Access Compliance Report Public Rights-of-Way (Curb Ramps)

Main Street: FOSTER_RD Cross Street: BRIMHALL_DR Location: SW

ADA ID: RPRK211207124525 Ramp Type: Type 1 - Perpendicular Diagonal Initial Pass/Fail: Pass Overall Compliance: No Severity Score: 10

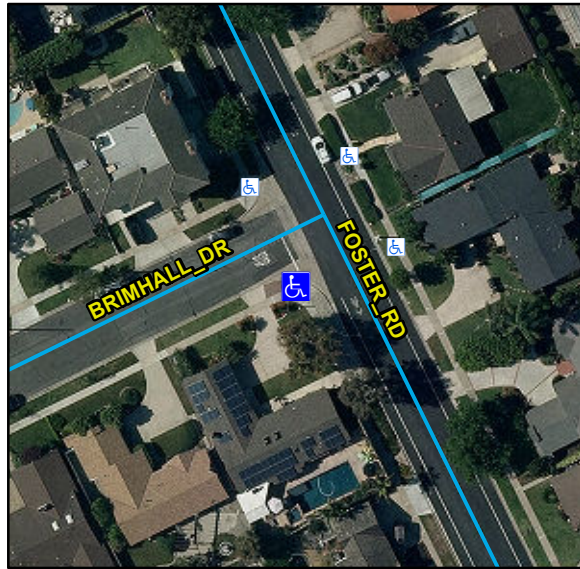
Compliance	Description	Data	Compliance	Description	Data
N/A	Ramp Length (in)	81	N/A	Flare Type LT	
Yes	Ramp Width (in)	48			Sloped
Yes	Ramp Run Slope (%)	6.3	N/A	Flare Slope LT (%)	4.8
Yes	Ramp Cross Slope (%)	0.4	N/A	Flare Traversable LT	No
N/A	Landing Present	Yes	N/A	Flare Type RT	
N/A	Landing Length (in)	51			Sloped
Yes	Landing Width (in)	48	N/A	Flare Slope RT (%)	1.4
Yes	Landing Run Slope (%)	0.1	N/A	Flare Traversable RT	No
No	Landing Cross Slope (%)	2.2	No	DWS Provided	No
N/A	Landing Movement Obstructed?	No	N/A	DWS Contrast	N/A
	Landing Movement Type	N/A	N/A	DWS Length (in)	N/A
N/A	Landing Shared	No	N/A	DWS Full Width	N/A
N/A	Clear Space	Yes	N/A	DWS Offset Left (in)	N/A
N/A	Clear Space To Crosswalk (in)	48	N/A	DWS Offset Right (in)	N/A
N/A	Marked Crosswalk 1	No	N/A	Marked Crosswalk 2	No
	Crossing 1 Direction	E		Crossing 2 Direction	N
	Marked Crosswalk 1 Width (in)	N/A		Marked Crosswalk 2 Width (in)	N/A

N/A	Ramp Inside Crosswalk 1	N/A	Yes	Ramp Inside Crosswalk 2	N/A
	Crossing 1 Slope (%)	9.9		Crossing 2 Slope (%)	4
	Crossing 1 Cross Slope (%)	2.1		Crossing 2 Cross Slope (%)	2.9
Yes	Gutter Ponding	No	Yes	Curb Slope	1.9
Yes	Gutter Lip Height (in)	0		Road Run Slope (%)	2.2
Yes	Gutter Run Slope (%)	0.7		Road Cross Slope (%)	2.2
No	Gutter Cross Slope (%)	3			
Yes	Overall Surface Condition: Acceptable		No	Perp Joint Present	No
	Cross Gutter Present?	Yes		Spandrel Present?	Yes
	Replace Cross Gutter?	No		Replace Spandrel?	No

Remove & Replace Curb Ramp With Two New Directional Ramps or Equivalent. Remove & Replace Gutter.

R204.3, R304.5.3, R305, STD 1115
